**ONSITE SEWAGE DISPOSAL SYSTEM**

**PERMIT: CONSTRUCTION**

PROPERTY ADDRESS: 17044 Hardy Road

Septic Installation Notes Cont'd  
17044 Hardy Rd.

**BAT PLAN  
 SHEARS PROPERTY  
 LOT 1**  
 A RESUBDIVISION OF POPLAR HEIGHTS SUBDIVISION  
 LOT 41-44 A5 RECORDED IN THE LAND RECORDS AS  
 PLAT No. 3, FOLIO 26

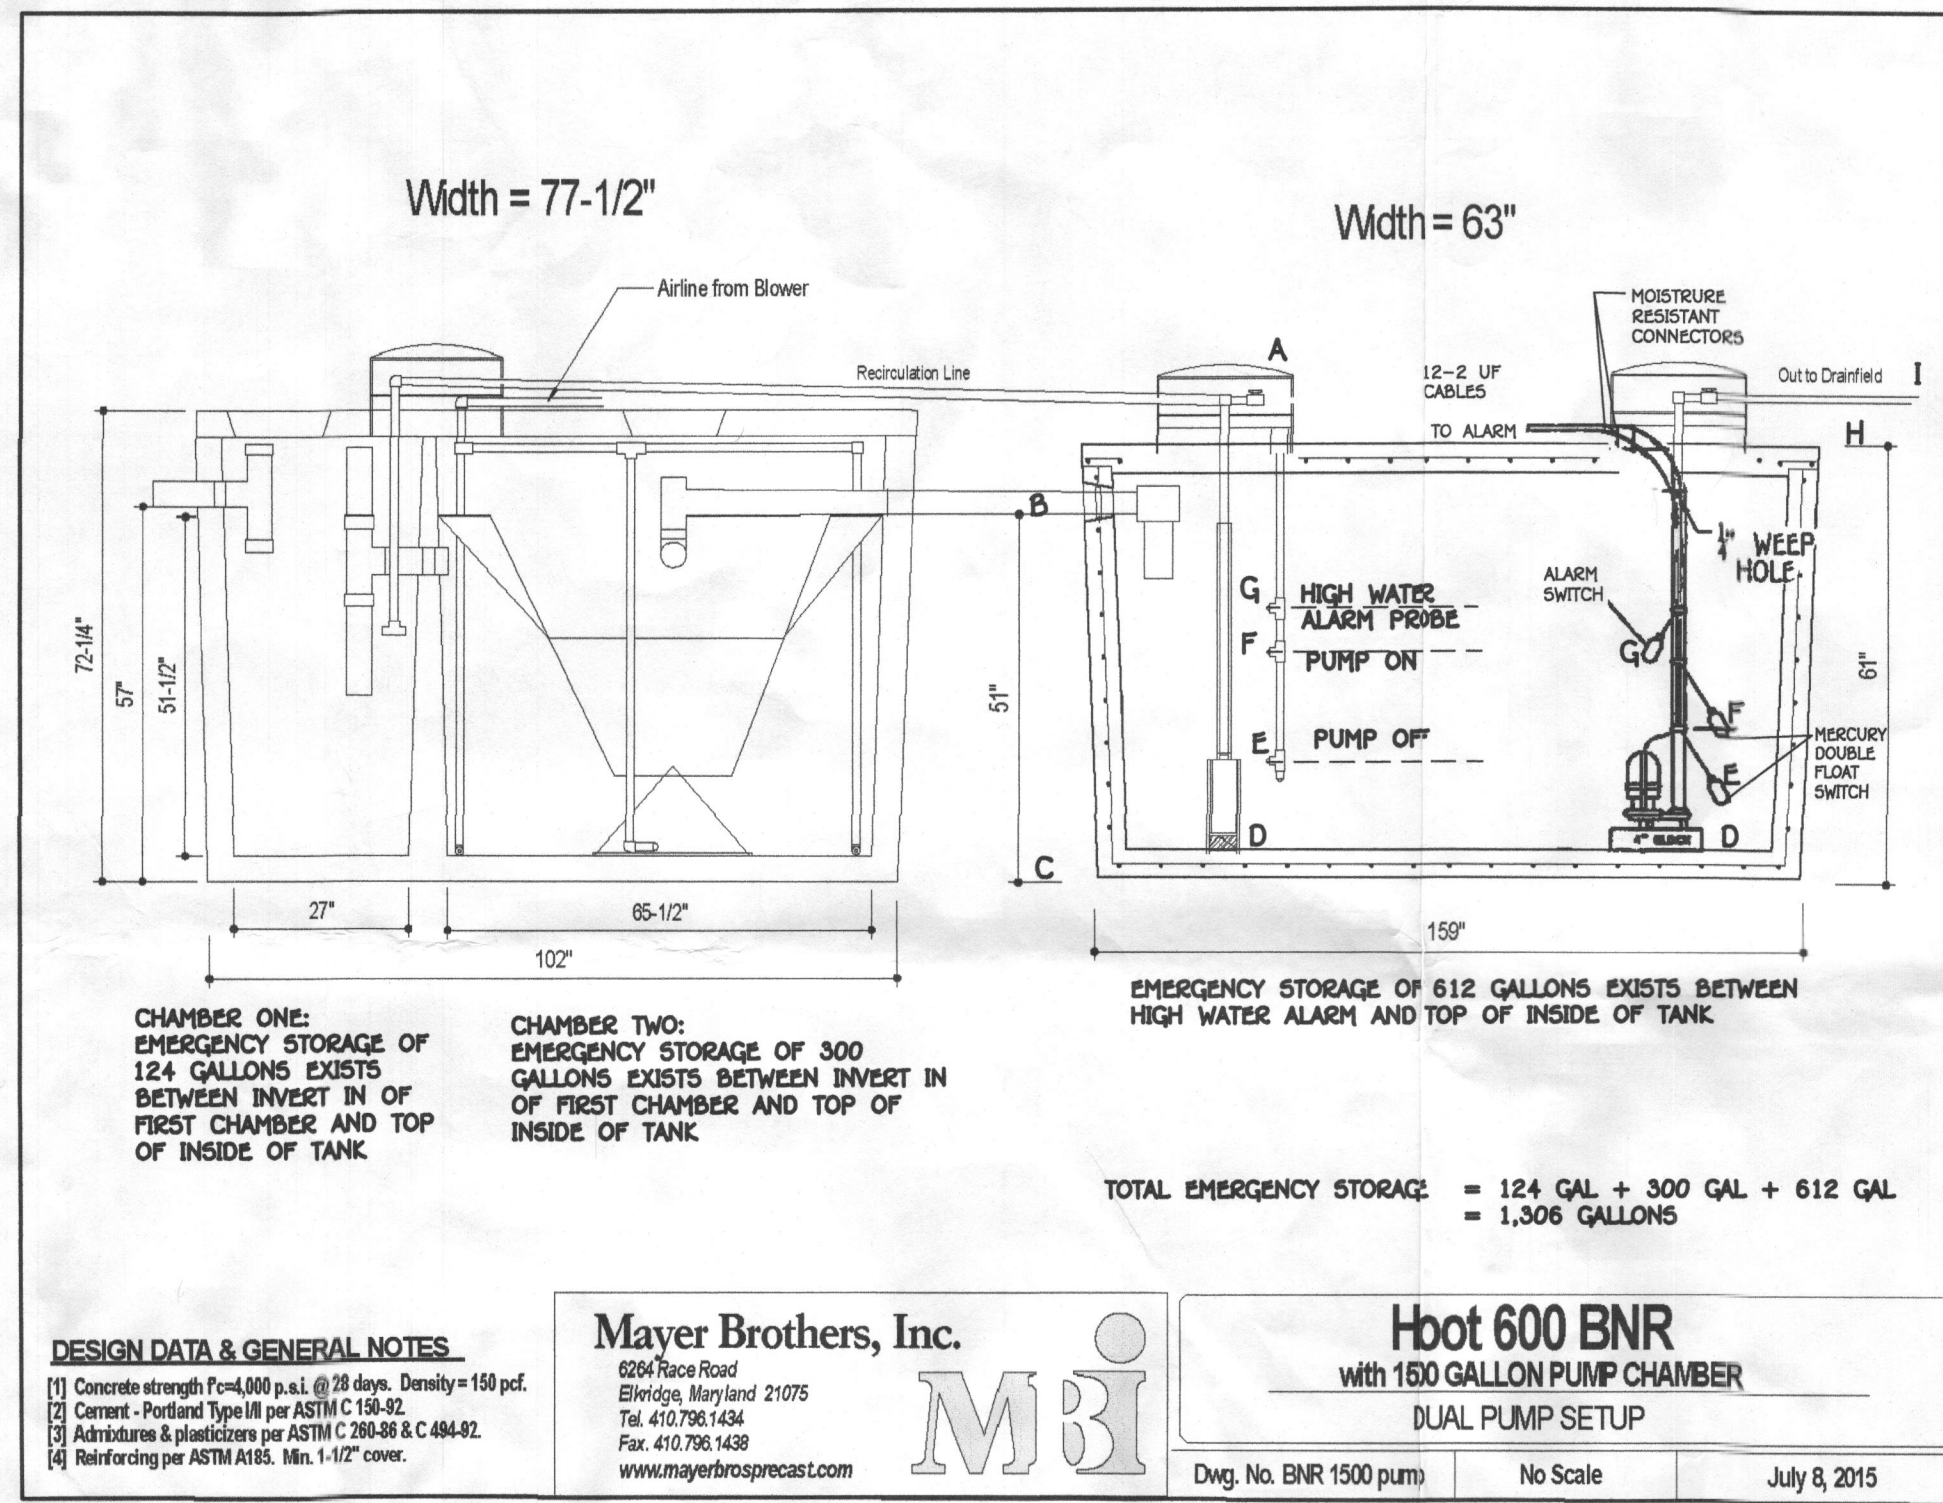
| DATE              | RESULTS OF REVIEW FOR FILE  |
|-------------------|---|
| 8/10/17<br>cont'd | recirculation good. Measured head heights @ lateral turn-ups:<br>IA1 = 12", IA2 = 12", IB1 = 31", IB2 = 30", IC1 = 36", IC2 = 36", ID1 = 36".<br>Called Kenny @ S. Carroll to verify model of pump installed;<br>IA1 and IA2 spec'd to be 2' lateral head. Pump alarm sounds. (S)   |
| 9/5/17            | S. Carroll switched pumps to 1/2 hp high head. Only 10" distal head at upper two lateral turnups.   |

We have an issue at the above referenced property. The septic system was installed per design specifications but the pressure test revealed only 12" distal head on trenches 1A1, 1A2. Trenches 1B1, 1B2 only got 30" distal head which the plan calls for 33" which is close but I am fine with this. The other trenches got 36"+. The pump that is installed is the one selected on the plan, Goulds WE051H. ½ hp. They recommended going to the ¾ hp pump but I thought that would be too much head. At nearly 70 gpm @ 11' TDH the ¾ hp pump is rated to 40' of head. The builder and septic contractor are both aware.

| DATE              | RESULTS OF REVIEW FOR FILE  |
|-------------------|---|
| 10/2/17           | After discussion w/ Engineer, solution was to select different pump make all together. I expressed "valving" the system to break the multiple segments into 2 zones. Informed contractor that 1/2 HP pump to be used, OK to "value" system in manifold or inside tank. (Hand)   |
| 10/11/17          | South Carroll uncovered T at manifold and found it was cracked. Replaced T and started up with original 1/2 hp pump - 18-20" lateral head at TIA1 + TIA2 lateral turnups. S. Carroll will split laterals into zones + install a gate valve at lower zone. (SC)  |
| 10/11/17          | S. Carroll installed a Y in the tank and a gate valve at lower zone. 3" PVC run parallel to original line to lower zone. Gate valve turns 7.5 turns to close; set at 5.75 turns closed. TIA1 + TIA2 lateral heights = 24-26"; IB1 + IB2 = 3'+; IC1 + IC2 = 34"; ID1 = 3'+. Need BAT startup certification. (SC) 10/16/17 BAT startup certification received. (SG) |
